M300 REPAIR PROCEDURE

SUBJECT: Noise in audio in certain Pitch shift programs.

REFERENCE: ECO 970422-00

1. Host Board Component Side (see page 5 for details):

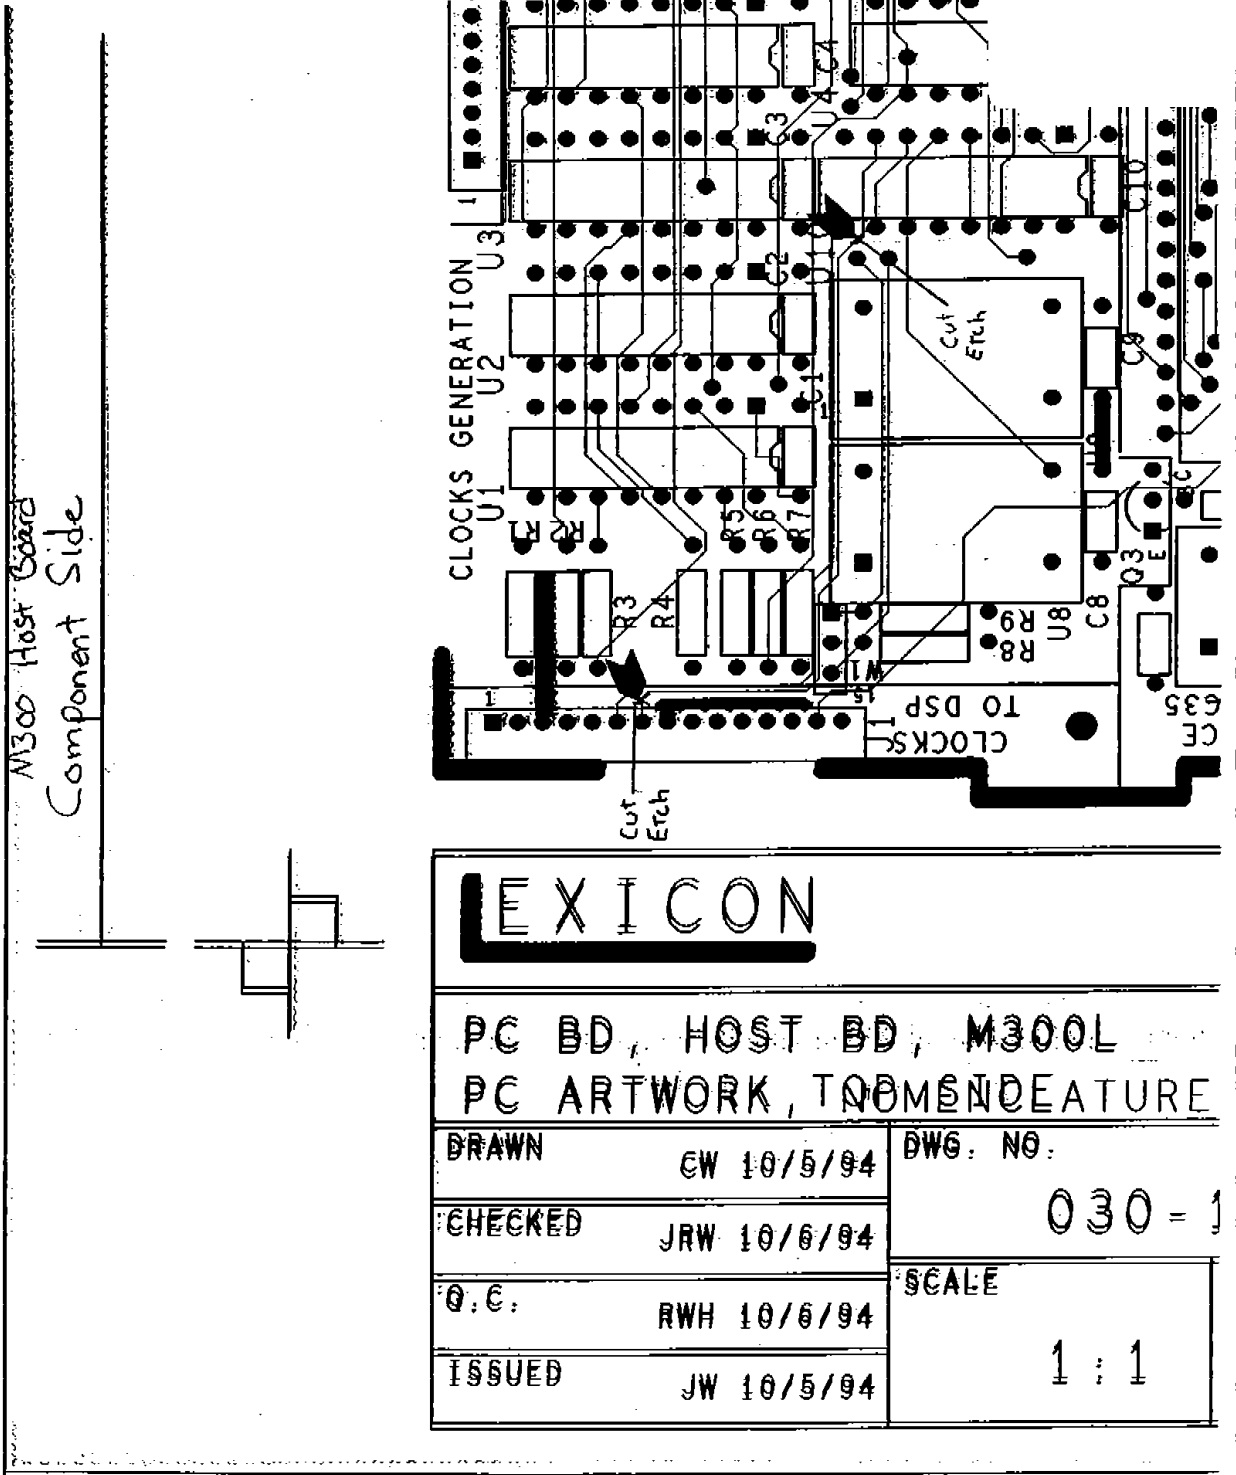
- Cut Etch at J1 pin 7
- Cut etch that runs between U10 pins 9 & 10.

Host Board Solder Side

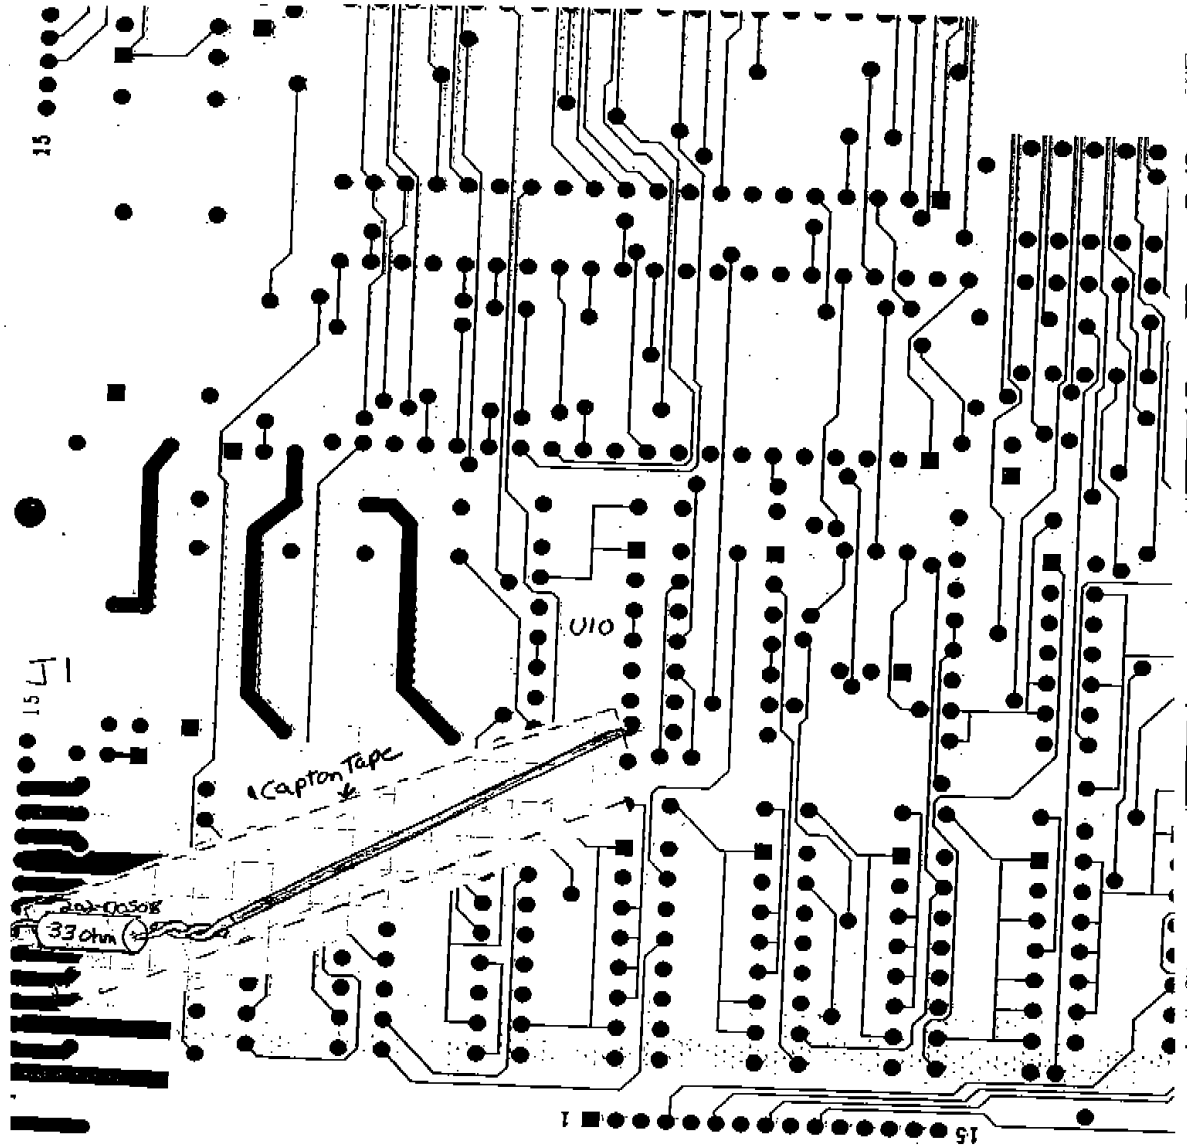
2. Host Board Solder side (see page 6 for details) :

- Apply 2" of capton tape from J1 pin 7 to U10 pin 7. Don't cover the pins.
- Solder one end of the resistor to J1 pin 7 and make a good mechanical connection (to workmanship standards) before soldering.
- On the other side of the resistor, remove all but 1/8" of component lead.
- Using 2" of 28AWG kynar wire, strip off 1/8" insulation on both ends.
- Make a good mechanical connection with one end of the kynar wire and the component lead of the resistor.
- Solder the connection.
- On the other end of the kynar wire, make a good mechanical connection to U10 pin7 and solder the connection.
